DEPARTMENT REPORT

SUBJECT: H-2025-0030
 Cherry Blossom East Subdivision

LOCATION: 523 W. Cedarburg Dr. and the 0.67-acre property to the east, located in the NE 1/4 of Section 12, T.3N., R.1W. (Parcel #R1386850820 & #S1212120695)

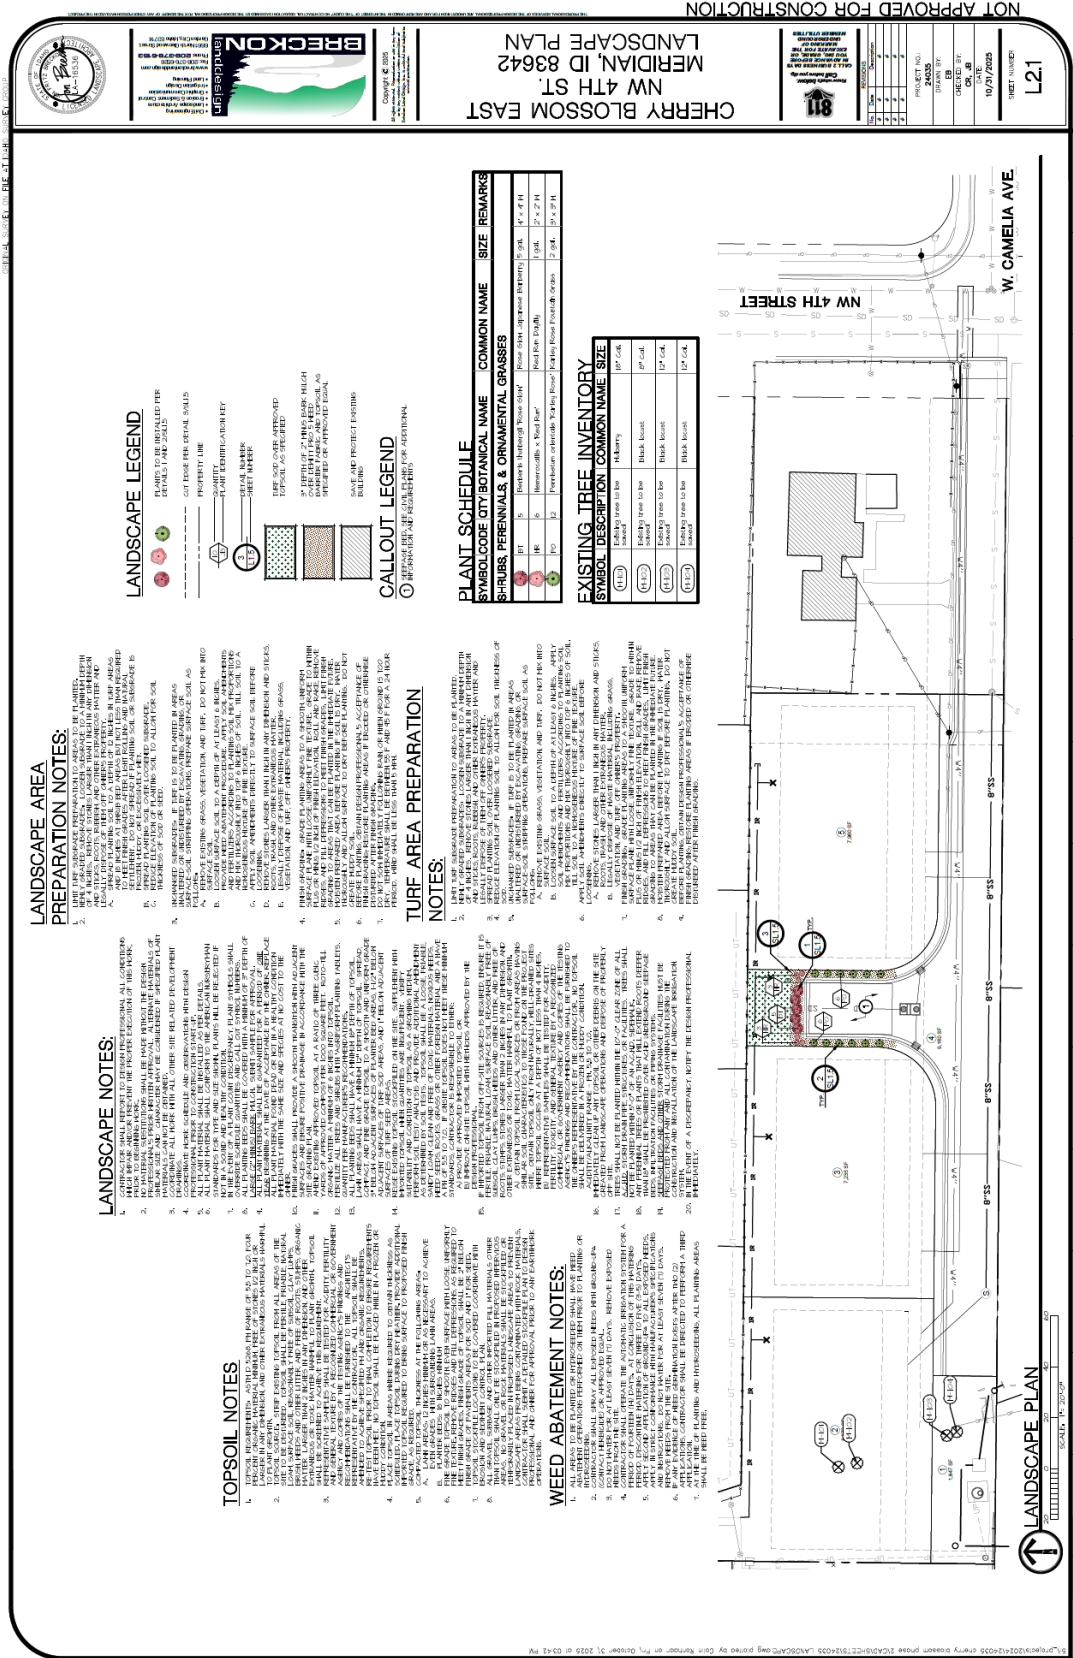
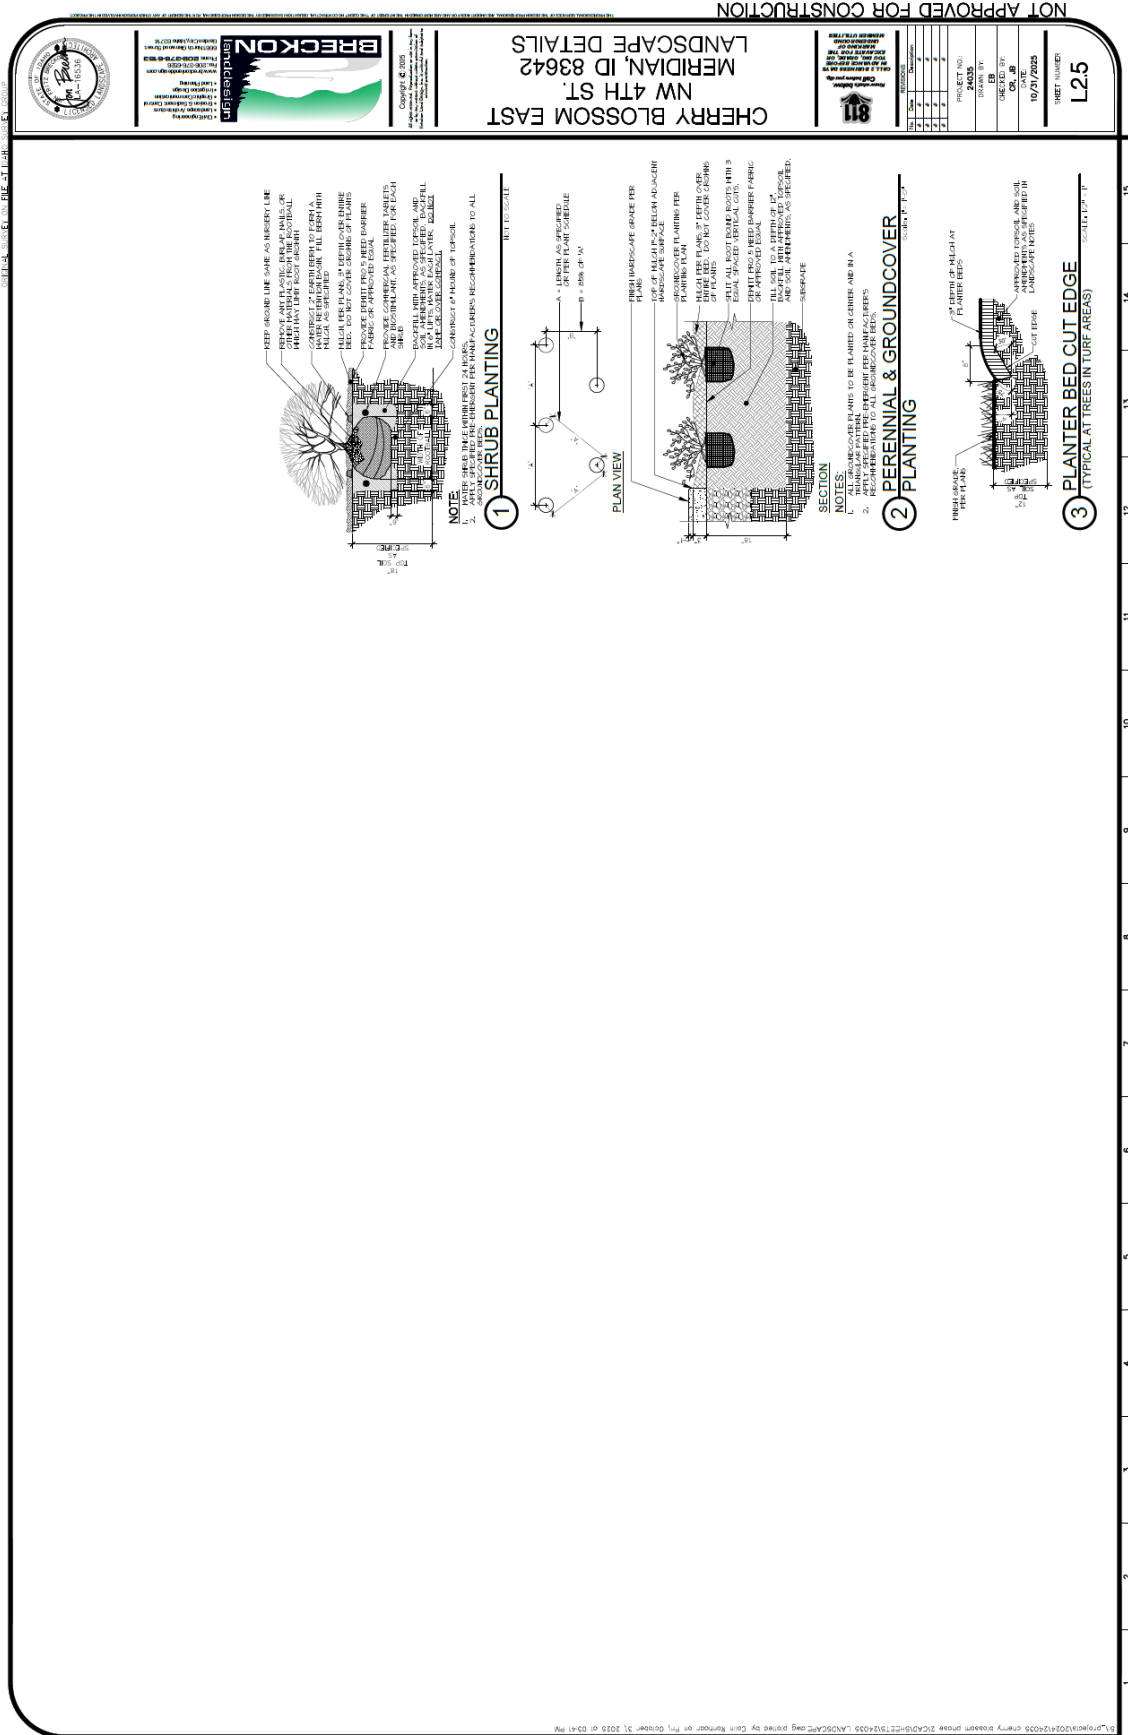
A common driveway is proposed on the subject property from the existing access easement for access to the proposed lots with a turnaround for emergency and waste disposal vehicles. The final plat depicts a street name (i.e. W. Camellia Ave.) for the common driveway, which needs to be removed as common driveways cannot be named, nor was a private street application submitted with the subject application.

There is an existing 30-foot-wide right-of-way (ROW) easement (Inst. #329628 and #379115) recorded along the southern boundary of the subdivision as depicted on the final plat and described in plat note #12. The Applicant's surveyor states the note is incorrect, that it's not ROW, and is an access easement that was determined to not be adequate to serve the proposed development. **If encroachments are proposed within the easement area or if the easement is desired to be removed, the easement(s) should be relinquished.**

- iii. Remove the private street name (i.e. W. Camellia Ave.) from the plat as common driveways cannot be named.
 - iv. Remove any existing easements that have been relinquished and include a note(s) with the recorded instrument number of the relinquishment(s).

- vi. Modify note #1 as follows: “. . . a ten (10) foot wide permanent public utilities and property drainage easement in hereby designated along all lot lines common to a private street the common driveway. . .”

- vii. Water service lines shall be depicted from the existing main line in N.W. 4th St. to the proposed building lots. A fire service line shall be provided from the existing main line to Lot 2, the furthest lot to the west, for an automatic fire sprinkler system as an alternative to providing another fire hydrant within the required distance to service this lot.

D. Landscape Plan (date: 5/7/2025 8/21/2025-10/31/2025)

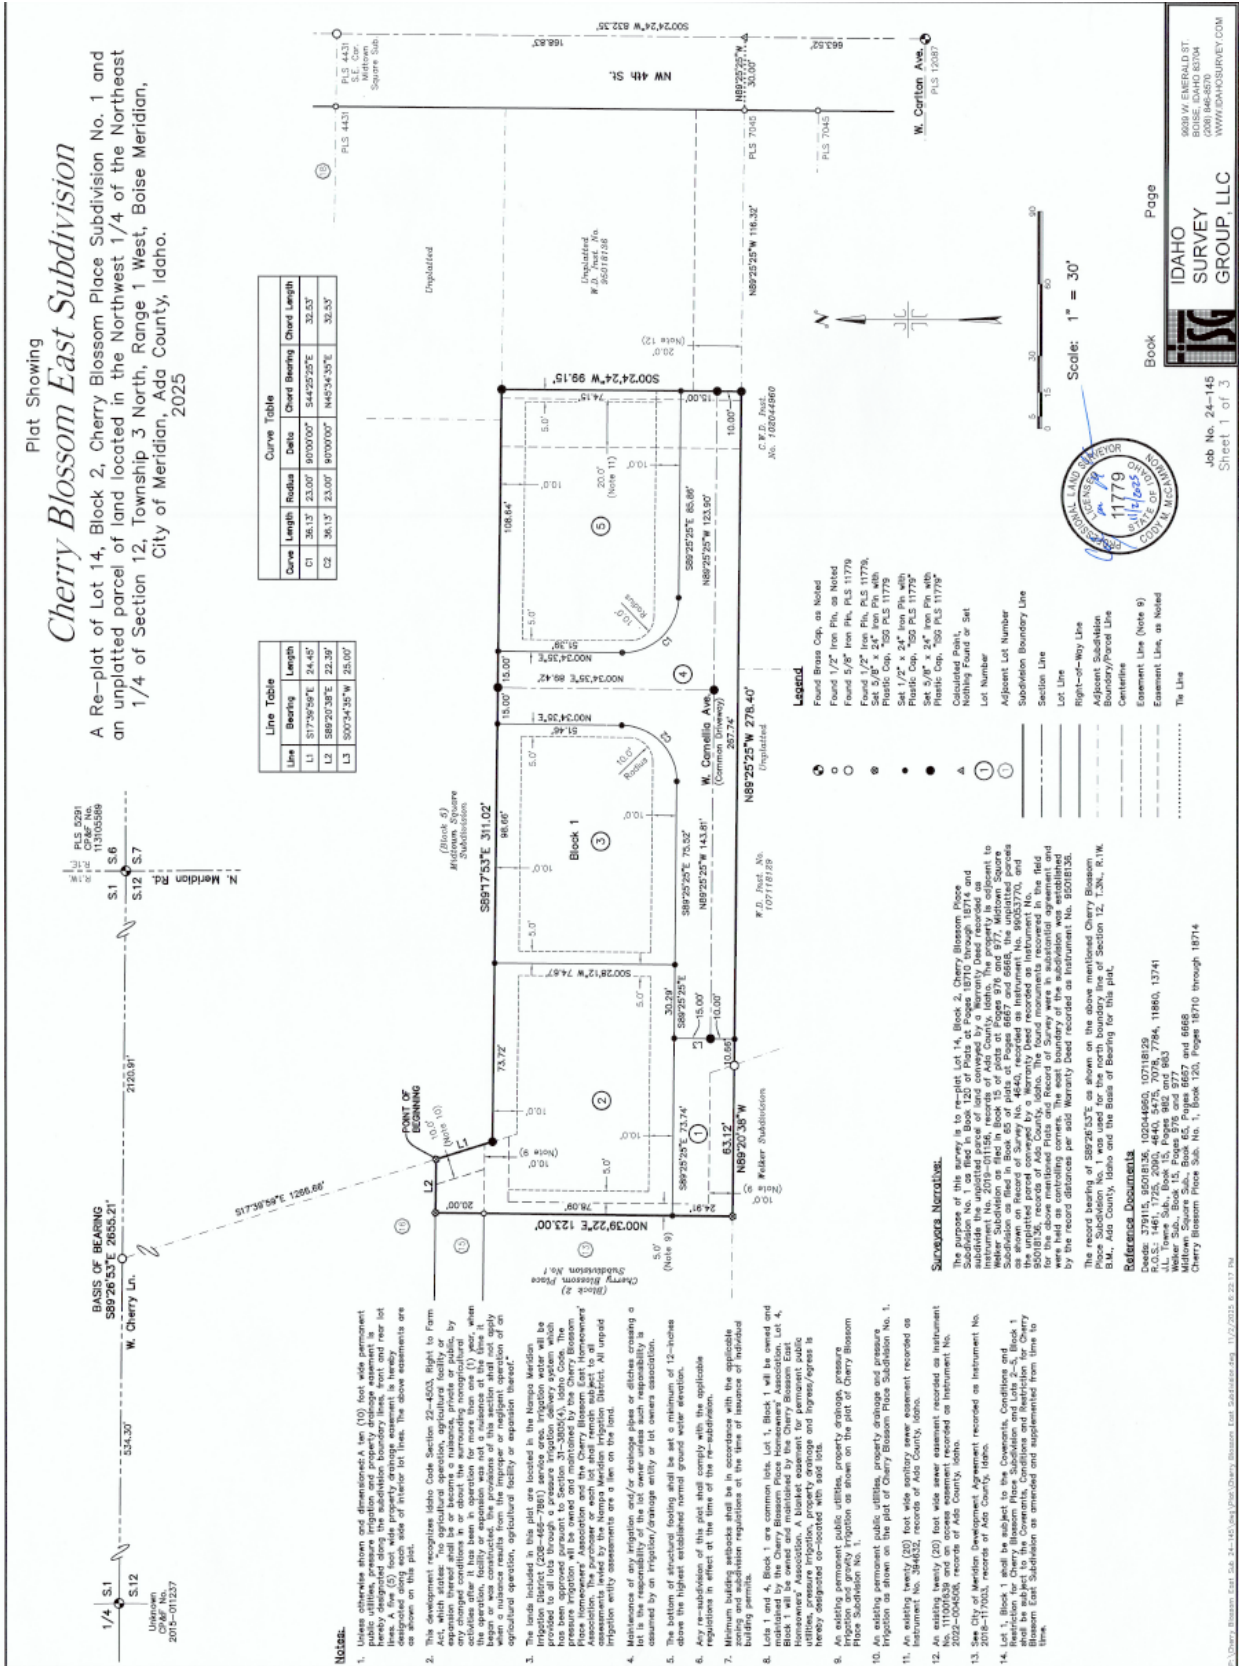
3. The landscape plan shall be revised as follows:
 - i. ~~Remove the fencing along the southern boundary of the property adjacent to the common driveway. The fencing has been removed.~~
 - ii. Ensure no trees are located within 10-feet of the water meter; revise plan accordingly.
